## Agilent Technologies 11757B/11758B Digital Radio Test System Firmware Upgrade Kit

Part Number 11758-90060 Supersedes: 11758-90045

## Firmware Revision Upgrade Kit

**Figure 1. Replacement ROMs Locations**

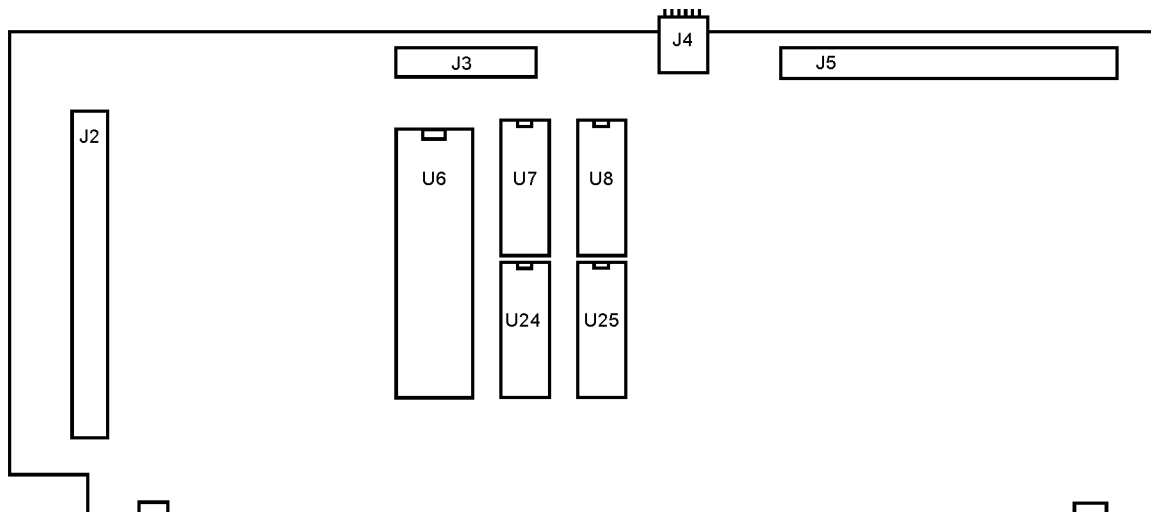
This kit contains the parts and instructions to install the firmware upgrade. No tools are required. Firmware versions 12.1 through 12.6 of the 11757B and 11758B Digital Radio Test System firmware produce an incorrect result when the “CCIR Dispersive Fade Margin” calculation is made. The error is corrected in firmware version 12.7. Firmware version 12.8 corrects the Year 2000 reported year format. Instruments having firmware versions 12.1 through 12.7 should be upgraded to version 12.8 by ordering the Firmware Upgrade Kit, part number 11758-61003.

1. Remove the instrument power cord, and then remove the feet and covers; these are secured at the rear panel.
2. Orient the instrument so that the rear panel faces you. Locate the processor board (A11), part number 08782-60036; it is located at the top left-hand side of the instrument.
3. Unscrew the processor board and plastic board holder, located under the processor board. Attach the processor board onto the board holder to keep it in place.
4. Refer to Figure 1. Locate and remove ROMs U7, U8, U24, and U25. Replace them with the new ROMs included in this kit, being careful to orient them properly. The replacement ROM part numbers are as follows:

U7: 11758-80067

U8: 11758-80068

U24: 11758-80069

U25: 11758-80070
